# ***Value Engineering Study Report***

## ***SR 8/US 78 at Mann Road/Mason Creek Road and at Post Road Intersection Improvements, Douglas County CSSFT-0008-00(375), PI No. 0008375***

***February 2012***

Subject: Final Value Engineering Study Report  
***SR 8/US 78 at Mann Road/Mason Creek Road and at Post Road  
Intersection Improvements, Douglas County, CSSFT-0008-00(375)  
PI No. 0008375***

### **Use a 4-foot shoulder in lieu of 6.5-foot on Bankhead Highway**

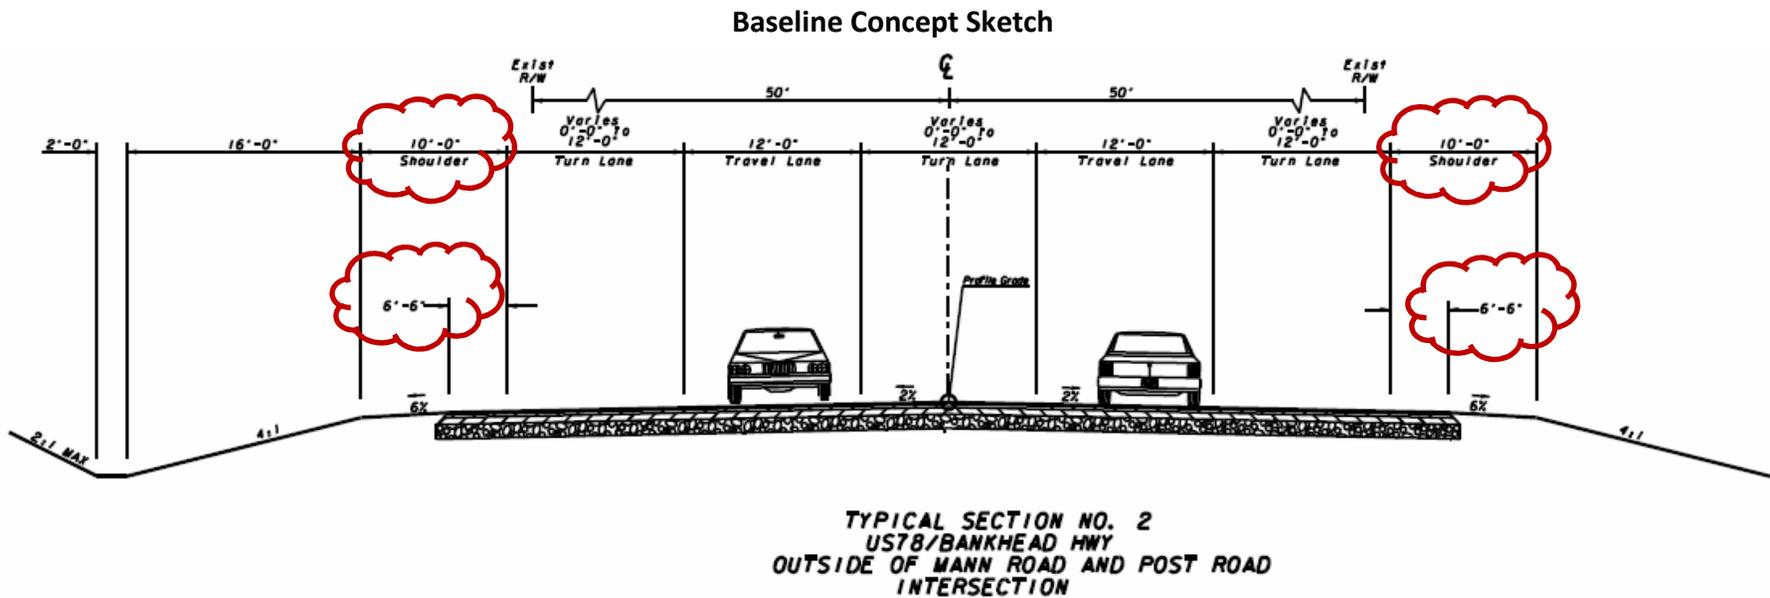
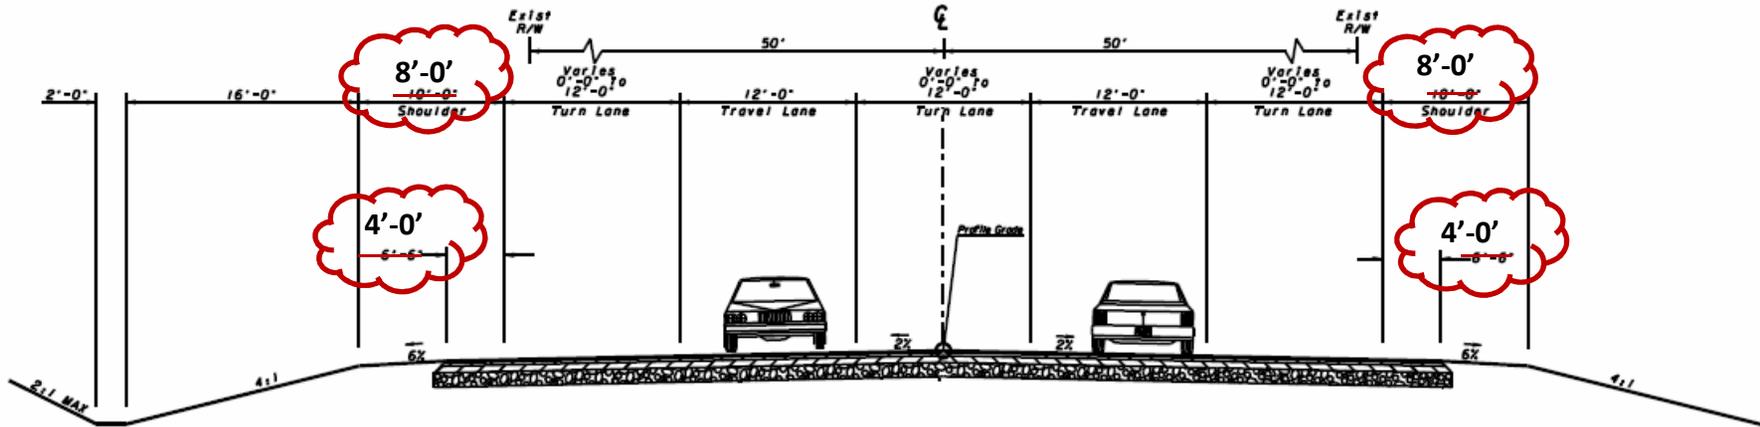
**Discussion:** The design speed in the provided plans for Bankhead Highway was 55 mph. The project's design speed for this mainline was changed from 55 mph to 45 mph, which changes different design elements like shoulder paved and total widths. Following the GDOT Design Policy Manual's guidelines for the design speed of 45 mph, these shoulders were reduced from 6.5 feet to 4 feet for the paved width and the total width was reduced from 10 feet to 8 feet. This reduces the cross sectional foot print of Bankhead Highway, which reduces the amount of pavement, grading, and right-of-way needed for construction.

**Description of Alternative Concept:** This project will now be designed for a 45 mph design speed. This allows the design criteria to change for the shoulder widths for paved and unpaved sections. The paved shoulder will now be 4 feet instead of the previously designed 6.5 feet for a 55 mph design speed. The total shoulder width can now be reduced to 8 feet instead of the previously designed 10 feet based on the new design speed criteria.

## VE ALTERNATIVE S-6

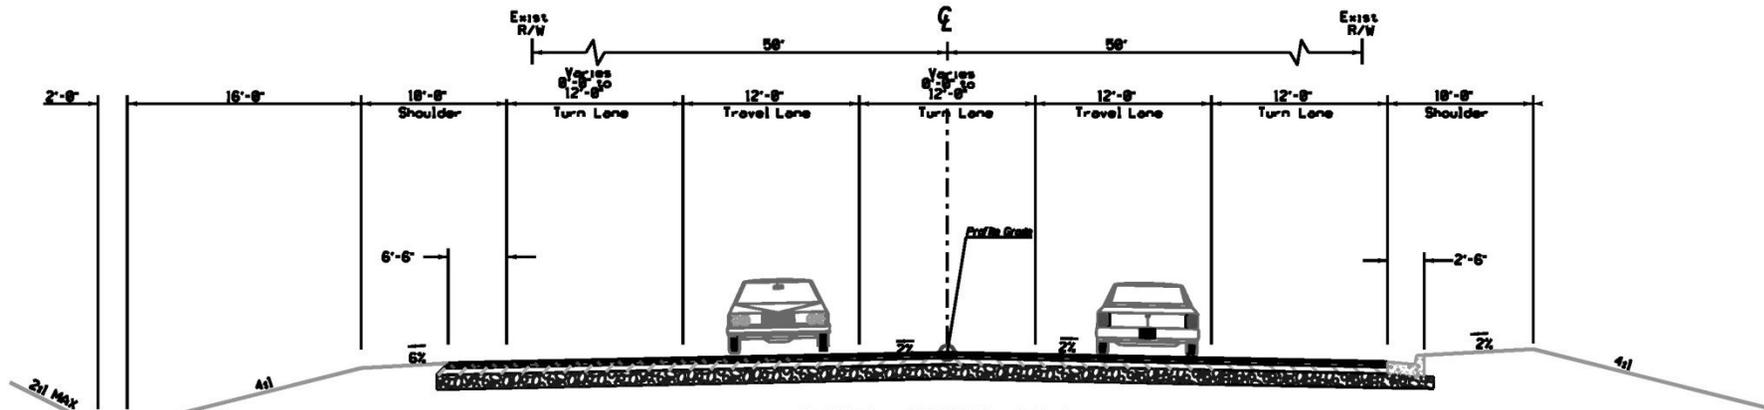
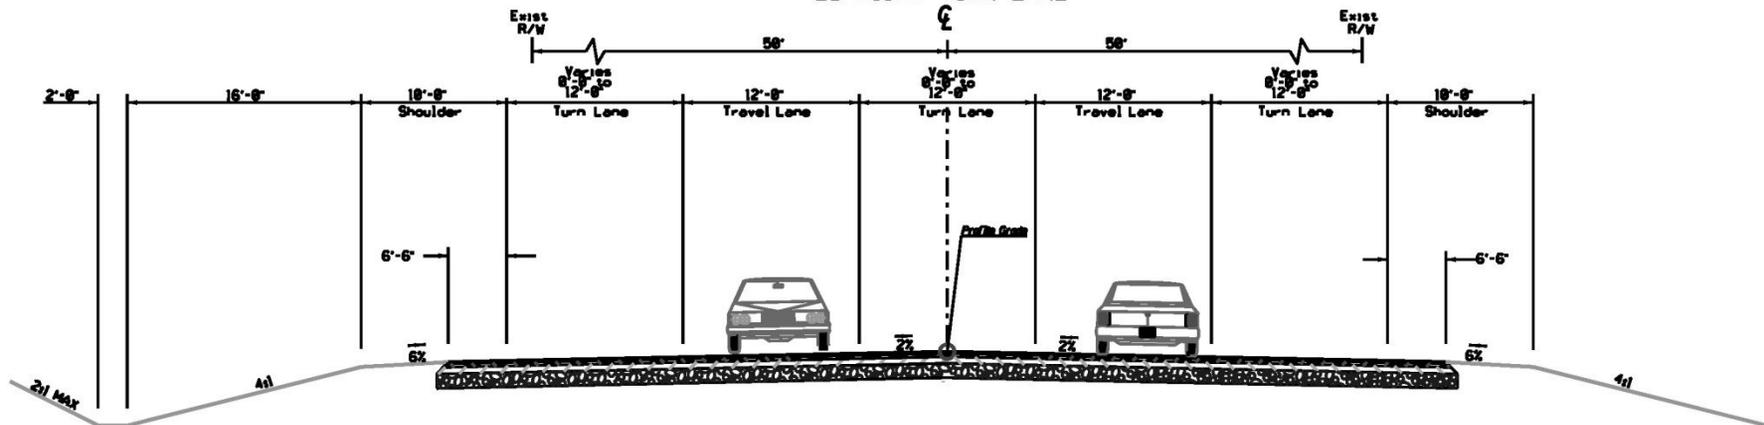
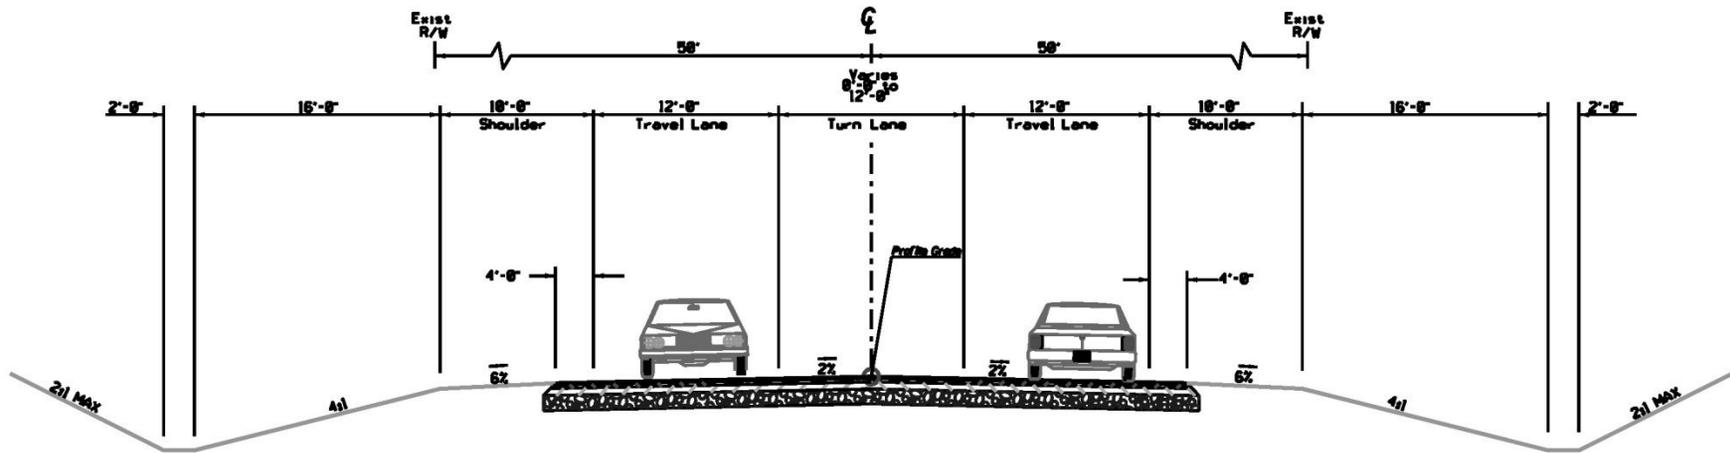
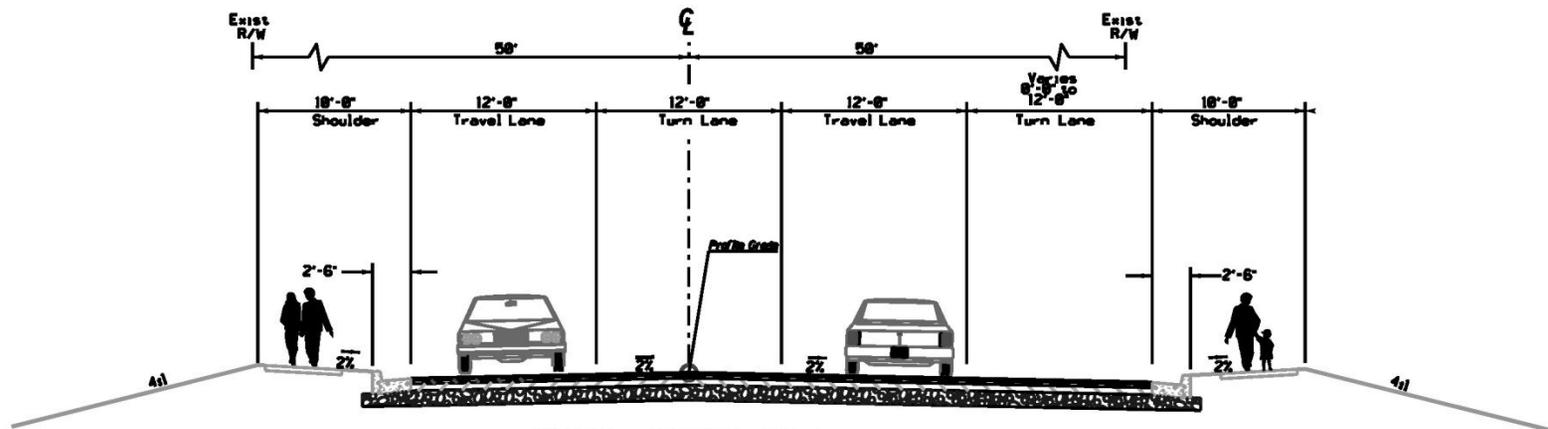
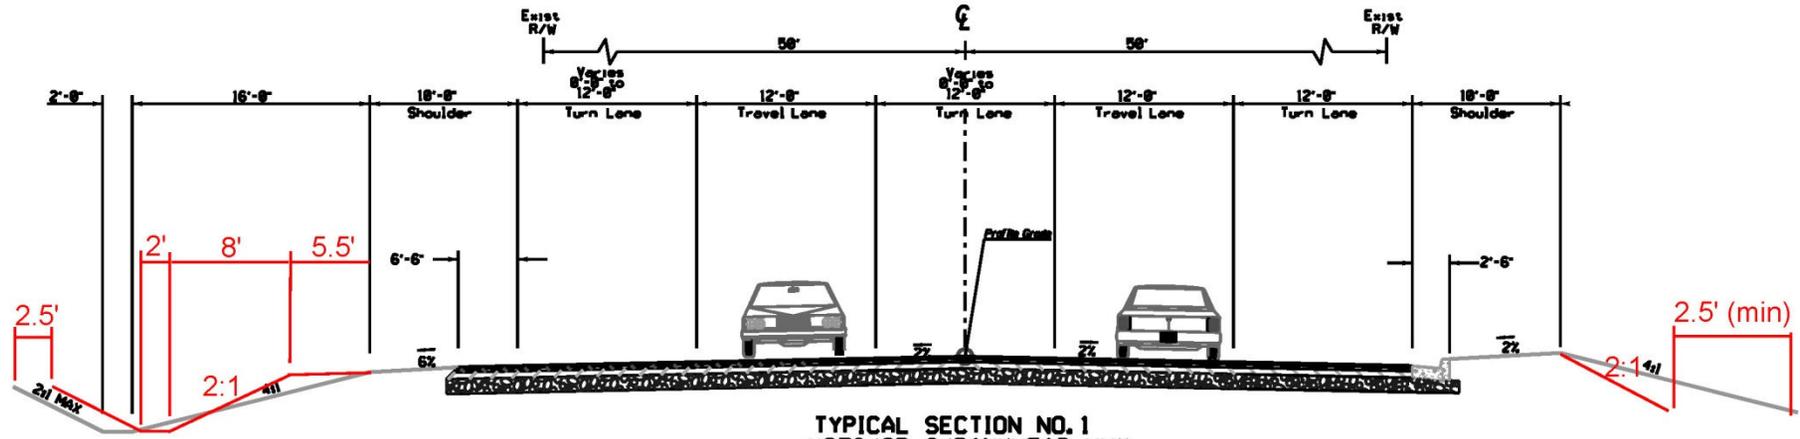
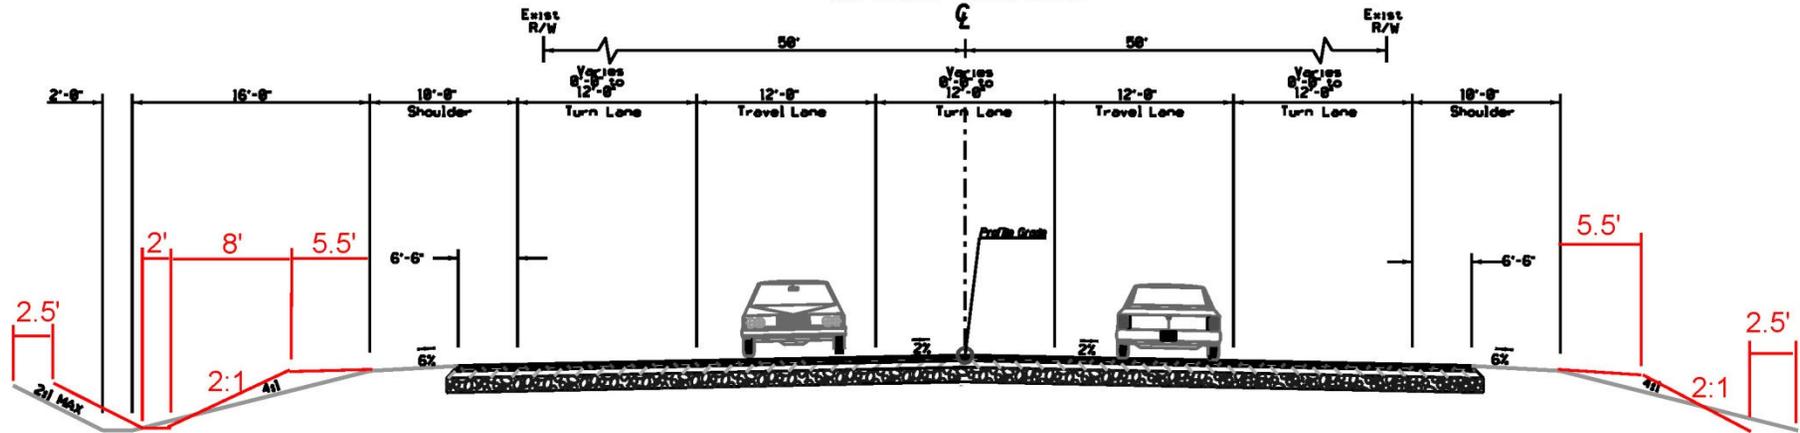
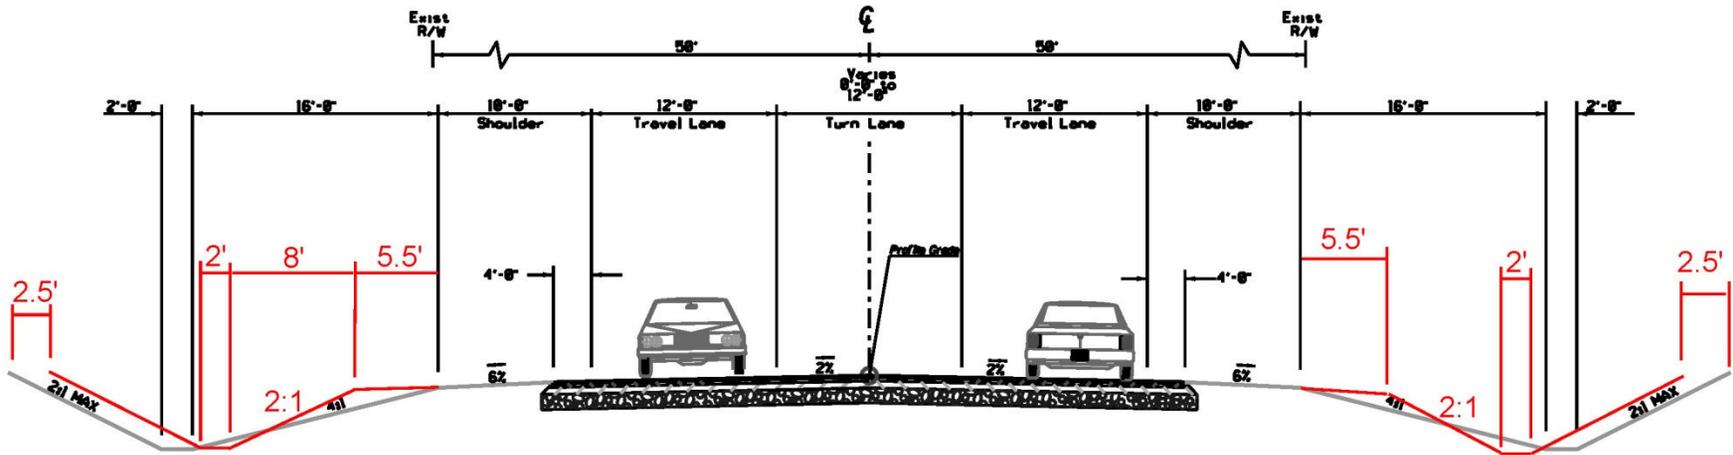
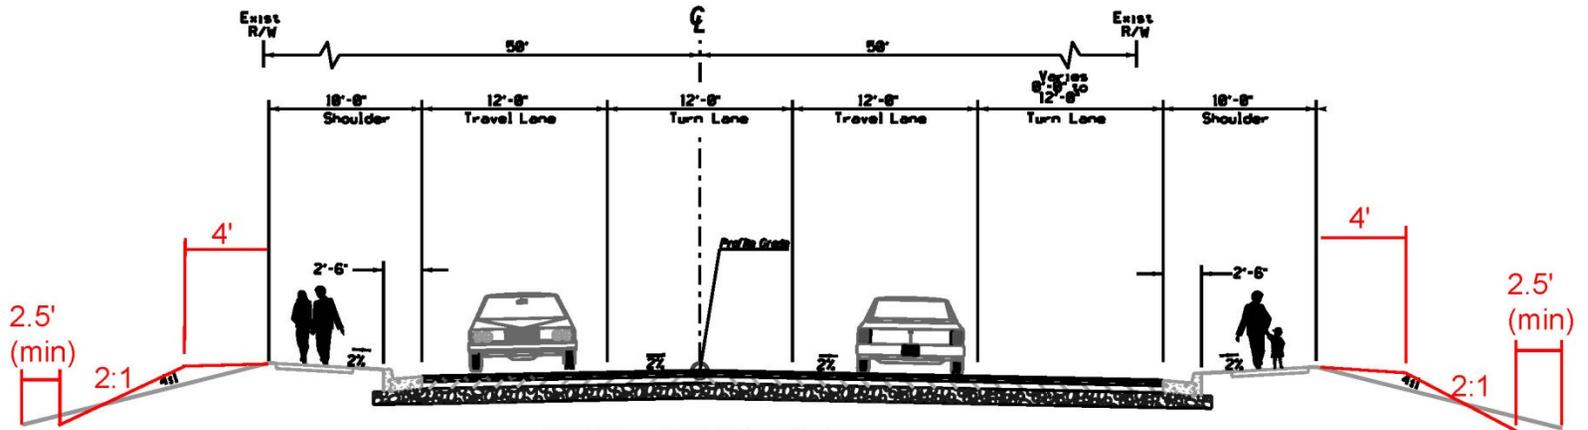
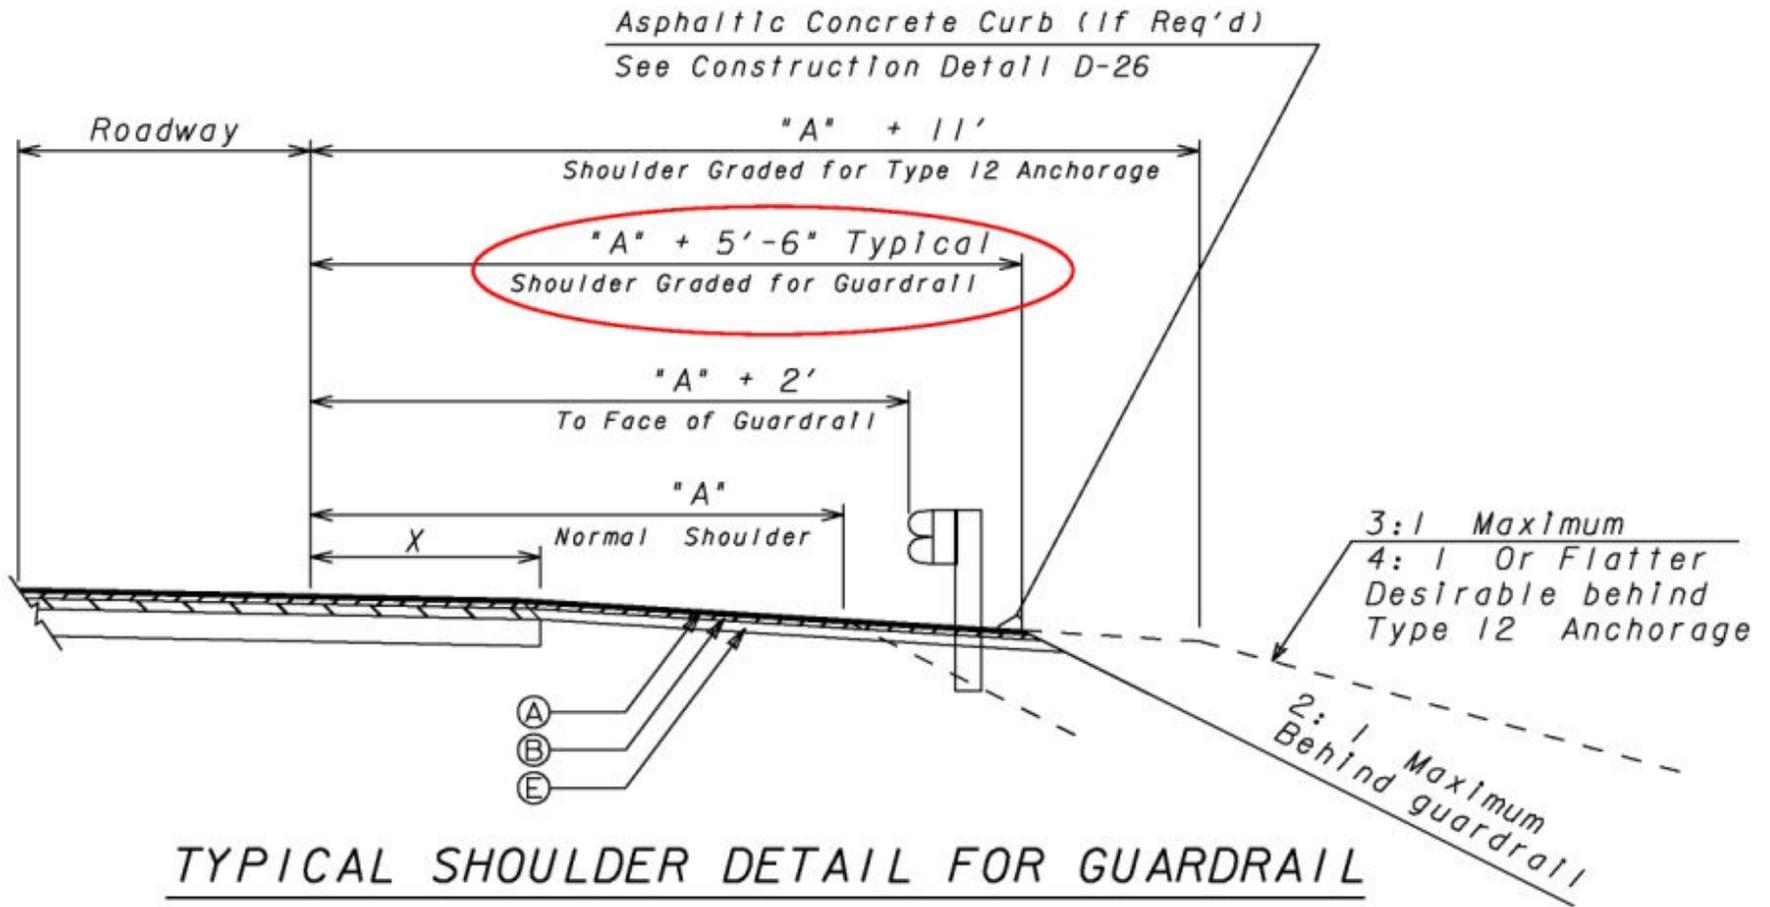
**Discussion:** GDOT Design Policy Manual states, "All front slopes (foreslopes) should be 4:1 or flatter, and no steeper than 2:1. GDOT discourages the use of 2:1 front slopes with guardrail unless economic constraints (construction costs, right-of-way impacts, or environmental impacts) outweigh the practicality of a 4:1 front slope." The need and purpose of the project is to reduce crashes and provide improved operations at the area intersections. The right-of-way costs are 56% of the total project cost. The projected savings accounts for right-of-way reductions only. Given the relatively low reduction in right-of-way needs, the implementation of this idea may not be justified.

The proposed 4:1 slope for 16 feet outside the shoulder breakpoint on Bankhead Highway and Post Road/Mason Creek Road/Mann Road would be replaced with a 2:1 for 8 feet outside the revised shoulder breakpoint. The revised shoulder breakpoint is 5.5 feet outside the baseline concept.

**Description of Alternative Concept:** Revise the 4:1 slopes to 2:1 and utilize guardrail in order to reduce the amount of right-of-way required. The shoulder will be widened by 5.5 feet to account for the additional width required for guardrail installation.
